Submission on behalf of SMTW Environmental DAC

***FOR DRAFT DECISION BY THE AIRCRAFT NOISE COMPETENT
AUTHORITY***

This submission is in response to ANCA's Aircraft Noise Consultation

Table 7 Population within Noise Level Band Data for Total Area L_{night}

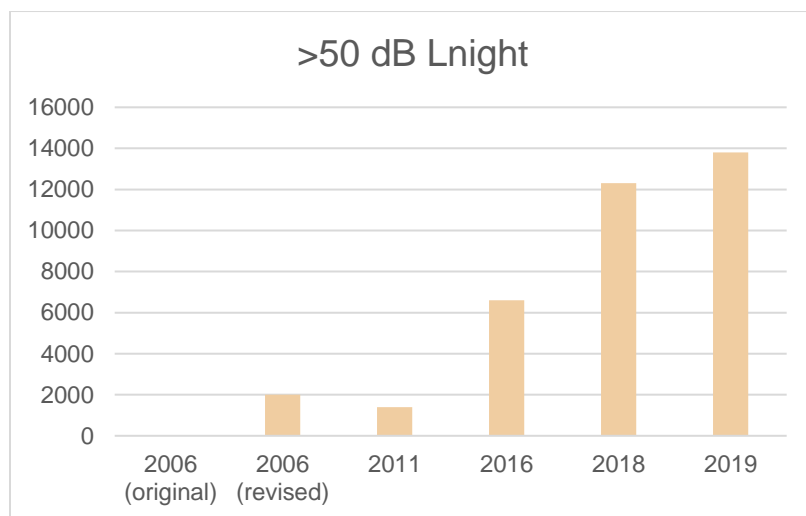
The original statistics from the 2006 NAP show zero people affected <50 dB L_{night}.

The chart above clearly shows an escalating noise problem over the 3 Rounds of the END.

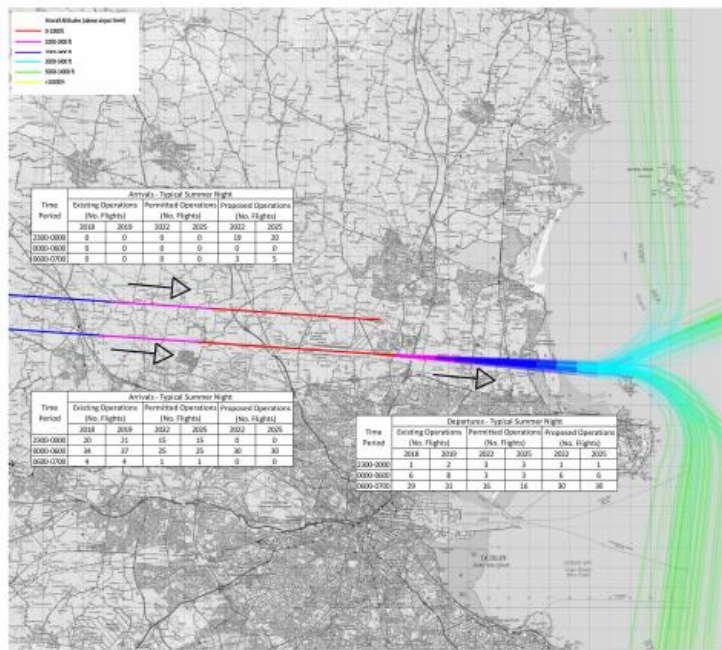
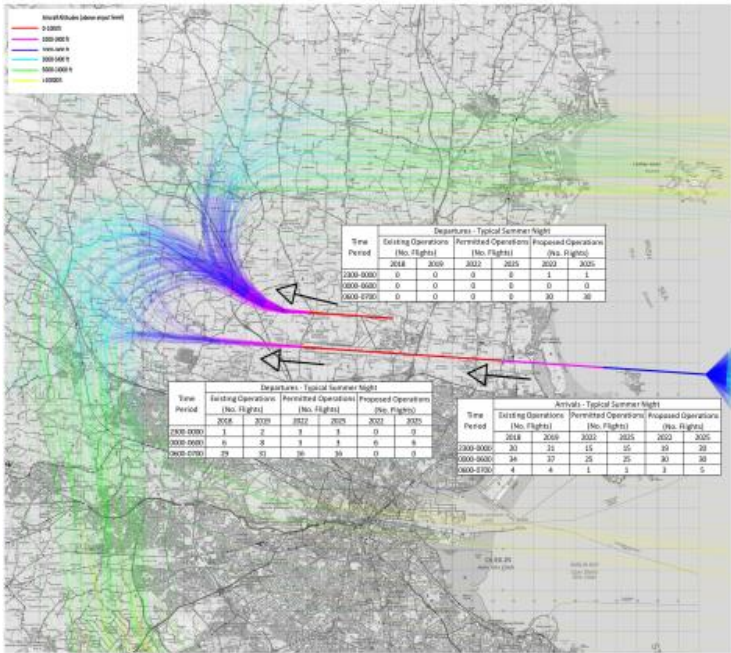
In the Heat maps for the initial EIARs, no movements are shown on the North Runway for Easterly Operations. In total it shows 37 departures on the South Runway for the night period with 30 departing between 06:00-07:00. Comparing that to the revised application, there are now 15 departures on the North Runway in an Easterly direction and 20 on the South Runway between 06:00-07:00.

For Westerly Operations, the initial EIAR shows 37 departures on the North Runway with 30 occurring between 06:00-07:00. The revised EIAR has 15 departures on the North Runway and 20 on the South Runway for Westerly Operations.

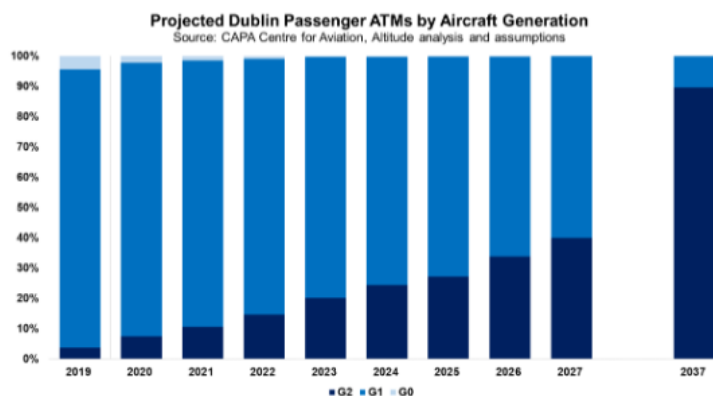
Comparing Tables 13B-4 in the revised EIAR and Table 13B-7 from the initial EIAR we find that the total forecast movements with 2025 Proposed is 235,883 compared with 240,788 movements with the original 2025 Relevant Action.

2025 Proposed has a lower number of movements but a far worse effect on the population affected by noise. This is of serious concern and ANCA needs to answer questions why it accepts this 2025 Proposed scenario when it effects a far larger population with respect to noise. And furthermore, it allows less flights.

Dublin Airport Development of Proposed Noise Measures

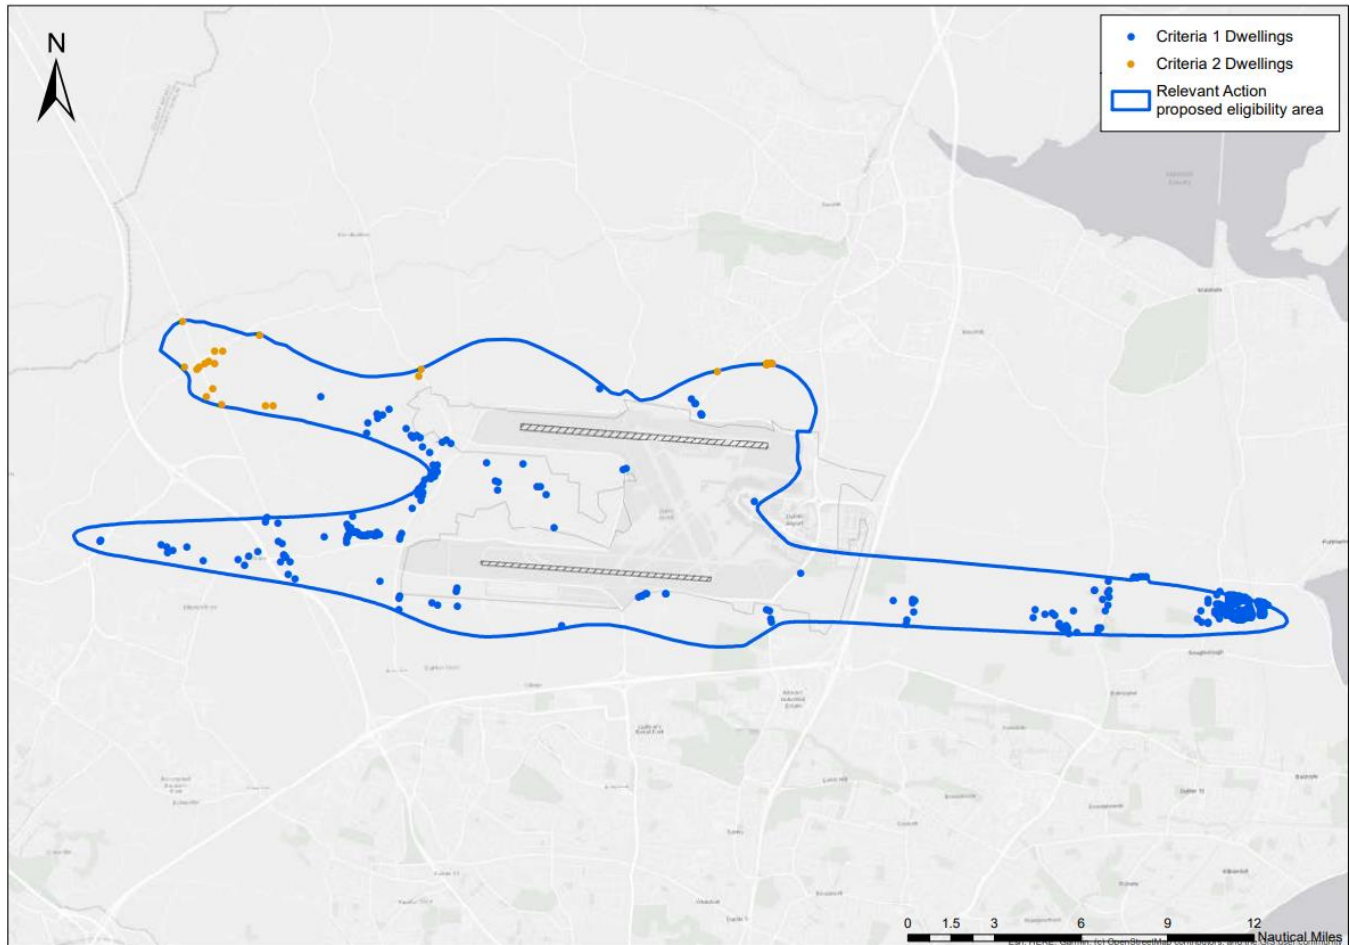
For Criteria 1, there are 180 dwellings requiring insulation in the >55dB L_{night} contour.

For Criteria 2, there are 54 dwellings requiring insulation based on >50dB L_{night} and a +9dB change.

Figure 12: L_{Amax} levels distribution for NMT 1, January - June 2020

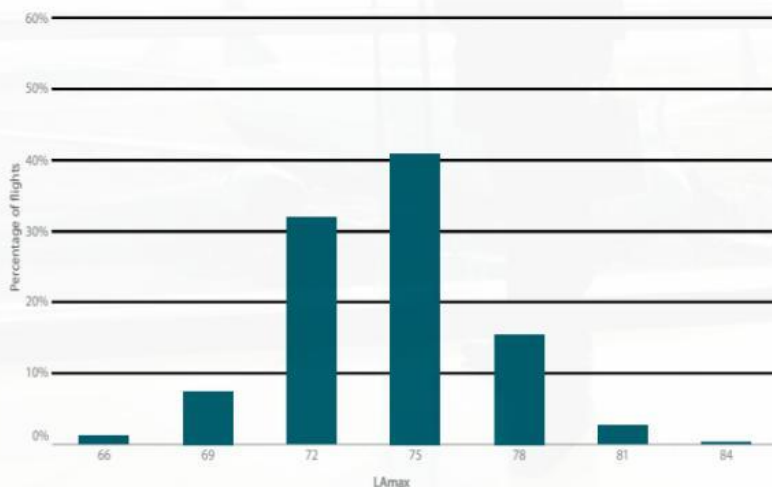
Figure 12 shows that approximately 58% of aircraft movements detected at NMT1 had a LAmax value > 75 dB. Approximately 18% had a LAmax value > 78 dB and 2.5% > 81 dB.

Table 13C-40: Existing Population Counts, N60 Metric

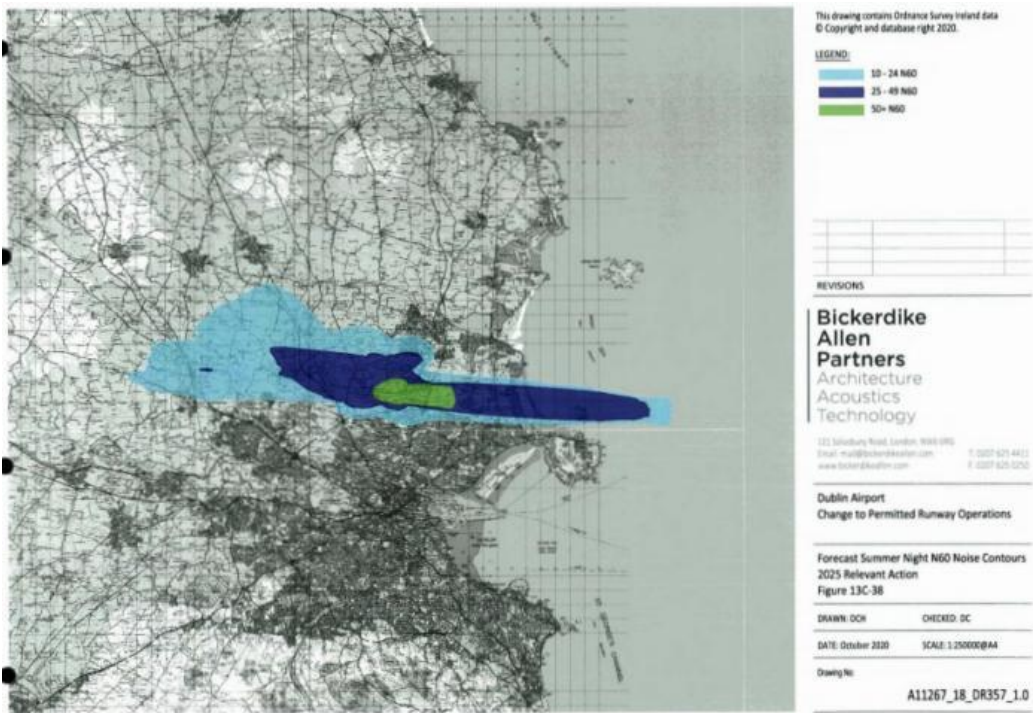
The ‘2025 Relevant Action’ scenario has 42% more people (61018 vs 42864) subjected to between 10-25 noise events compared with ‘2025 Baseline’.

Based on the ProPG Guidelines, 61018 people will not be able to sleep with their windows slightly open or risk having their sleep disturbed, with the ‘2025 Relevant Action’ Scenario.

Noise Complainants Analysis 2021 V 2022

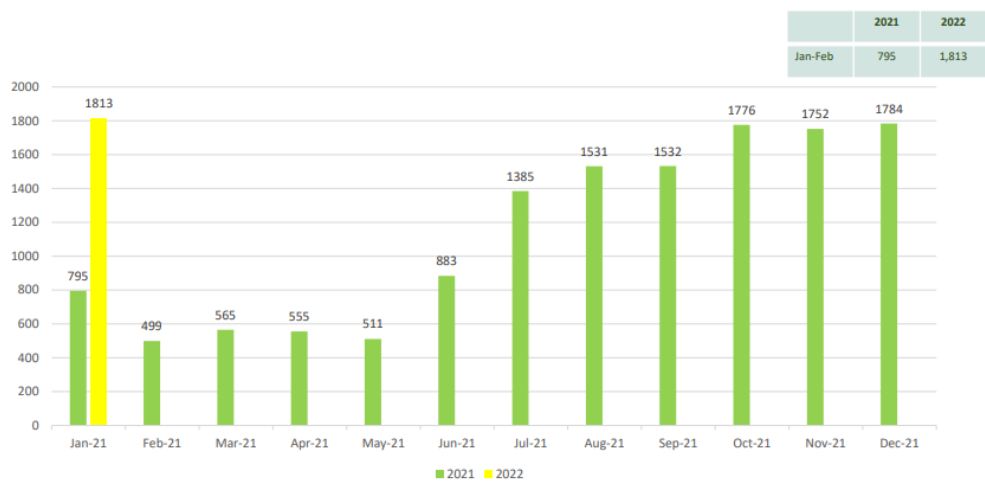
The daa produce monthly Noise & Track Monitoring Reports. The latest report on their website is for January 2022 (<https://www.dublinairport.com/docs/default-source/airport-noise/01-dublin-monthly-jan-2022.pdf>). In January there were 1813 noise complaints. This is a significant increase on January 2021.

Noise Complainants Analysis 2020 V 2021

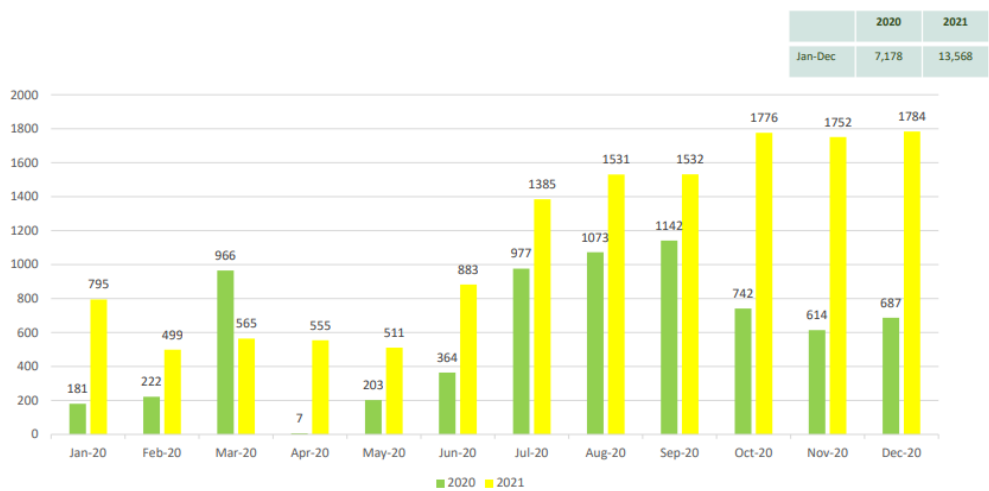
In the December 2021 report, it is clear to see the increase in noise complaints over the whole year.

There is no mention of noise complaints in ANCA's draft decision. How can the public have trust in the Noise Regulator if it fails to examine noise complaints? Why should the public complain if nothing is going to be done by the Regulator?
